**Re: Kellyville Station Precinct Riparian Assessment – Response to Submissions**

**Table 1: ELA response to Riparian Assessment submissions**

# Kellyville Precinct State Significant Development Application - Riparian Assessment

**Figure 2: Encroachment into inner and outer vegetated riparian zones following adjustment of development footprint (as contained in Riparian Assessment version 5 dated 30/4/2020).**

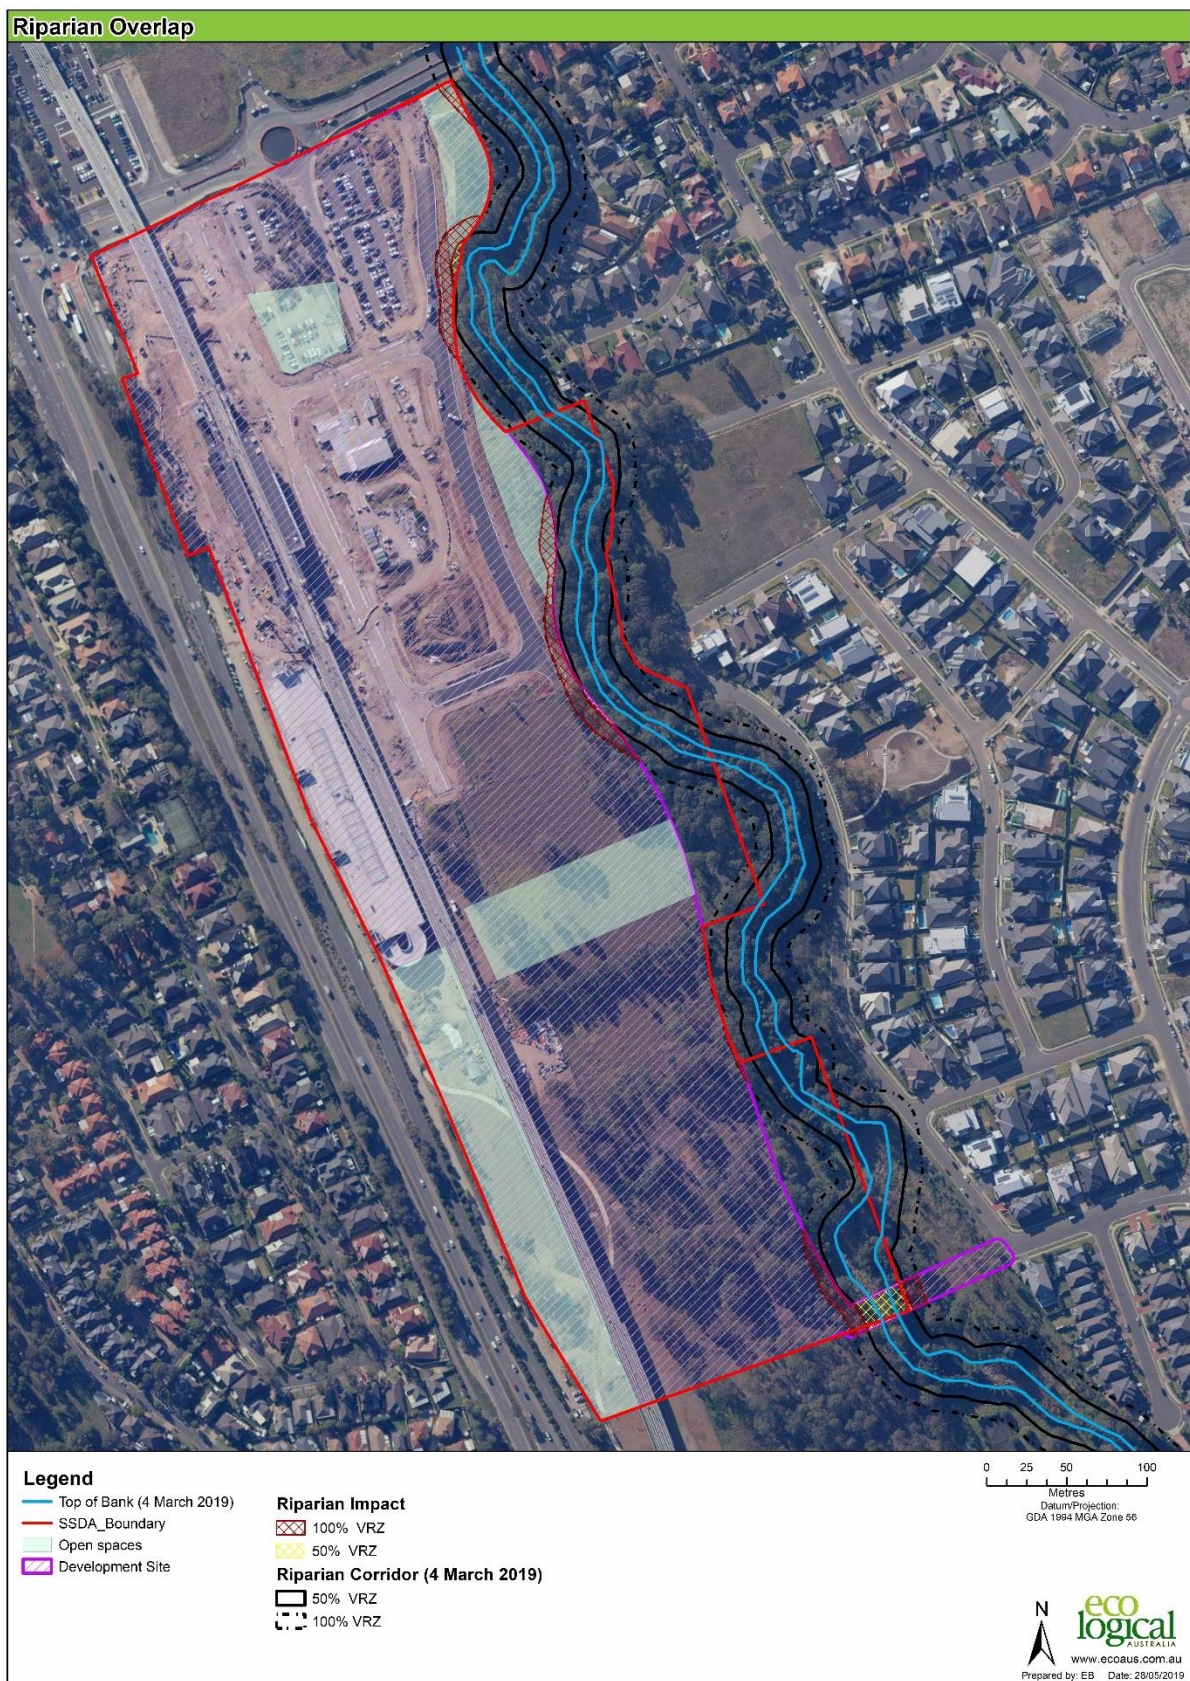
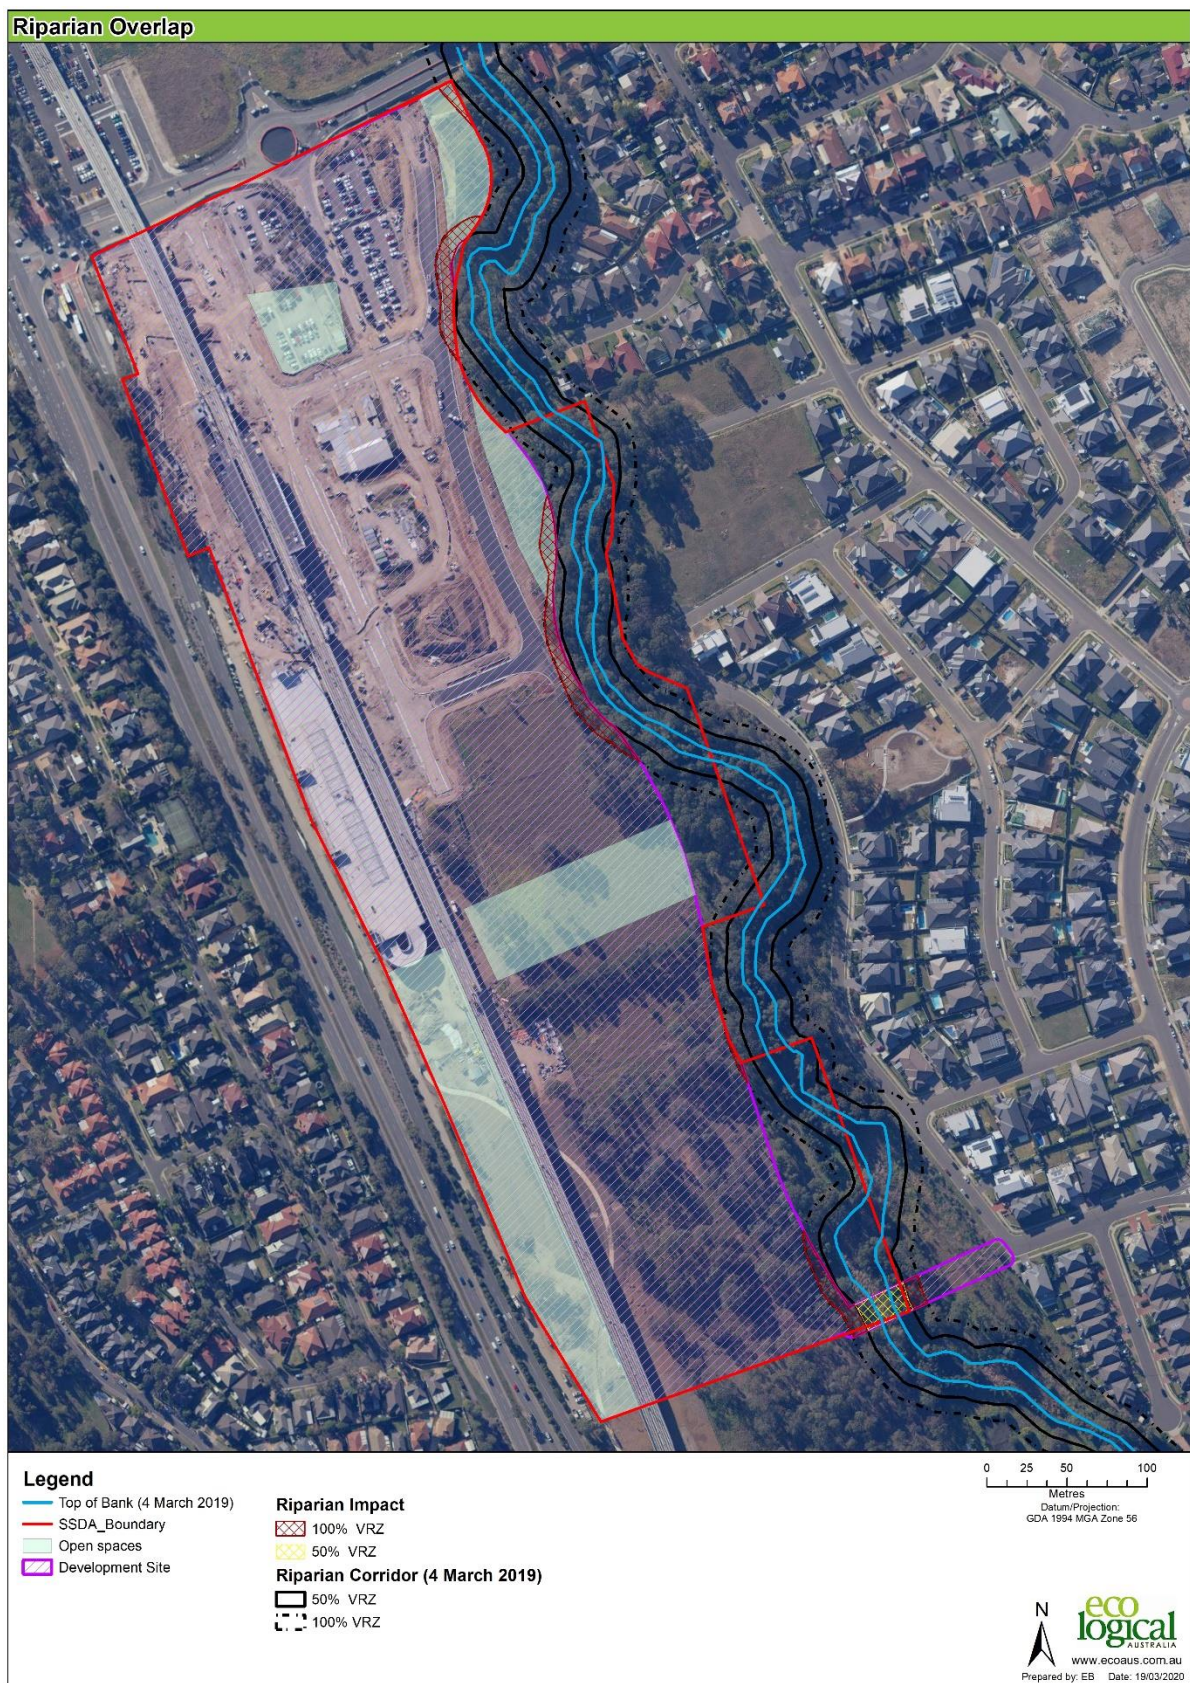
Agency	Comment	ELA Response	Section in Report
DPIE – Water and NRAR	The project proposes to impact on the inner fifty percent of the vegetated riparian zone. This proposal is not aligned with the Guidelines for Controlled Activities on Waterfront Land (NRAR 2018) and should make appropriate adjustments to ensure compliance.	<p>The proposed development footprint has been adjusted to ensure that there is no impact to the inner 50% of the vegetated riparian zone (VRZ), apart from indirect impacts caused by shading from the proposed road bridge in the south of the study area. Figure 1 below shows the original encroachment into the inner and outer VRZs and Figure 2 below shows the encroachment into the inner and outer VRZs following adjustment of the development footprint.</p> <p>While the bridge will cause the watercourse to be shaded within this area, the field survey carried out in February 2019 observed that Elizabeth Macarthur Creek within this area was densely covered in <i>Typha orientalis</i>, which was restricting the amount of light reaching the water. The bridge construction would not prevent light from reaching a watercourse that is currently completely unshaded. The indirect impact to the inner VRZ as a result of shading from construction of the bridge is unlikely to be significant.</p> <p>The Vegetation Management Plan should include shade-tolerant vegetation to be planted within the area where the proposed bridge is to be constructed, in order to ensure that the vegetation within this area survives under new conditions.</p>	Section 6.3 and 6.4

**Figure 1: Encroachment into inner and outer vegetated riparian zones (as contained in Riparian Assessment version 3 dated 19/8/19).**
